MEMORANDUM

SUBJECT: Permit Renewal Staff Analysis: City of Dubois Wastewater Treatment and Reuse Facility; LA-000166-02.

Figure 5.1 Hydraulic loading rates

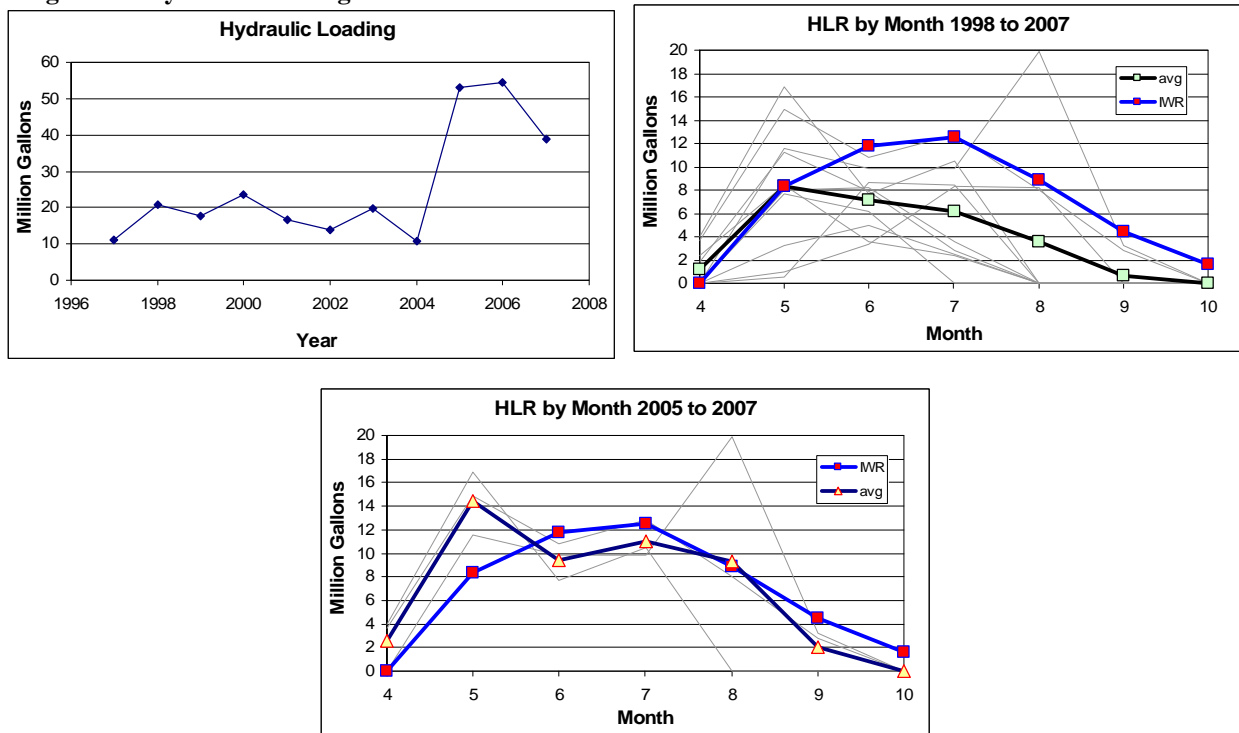
Hydraulic loading at the Dubois facility appears to be excessive in the early months of the growing season, based on irrigation water requirement (IWR, University of Idaho, Kimberly R & E Center) and annual reports. Figure 5.1 *Hydraulic Loading Rates* shows actual irrigation and crop IWR, and a recent trend toward over application in the early growing season.

The irrigation schedule, required with this permit revision, should address timely application of stored wastewater and irrigation water, and thereby increase treatment efficiency and reduce chances of wastewater infiltrating beyond the crop root zone. If the recent increase in available water is an anomaly, the facility may also want to consider decreasing crop acreage to better accommodate water availability, as well as utilizing the maximum drawdown permissible for lagoon (cell) B, as outlined in the facility O&M manual.

Figure 5.2 Total Nitrogen and COD Loading Rates

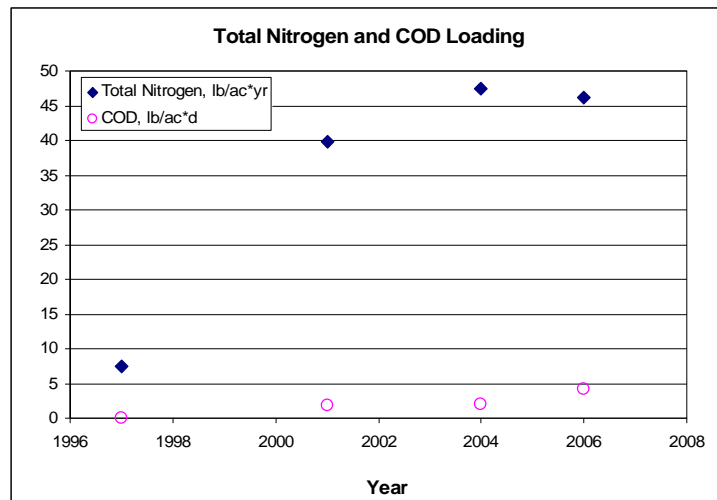
Sampled nitrogen and COD loading rates are shown in Figure 5.2. Actual loading rates are below recommended limits.
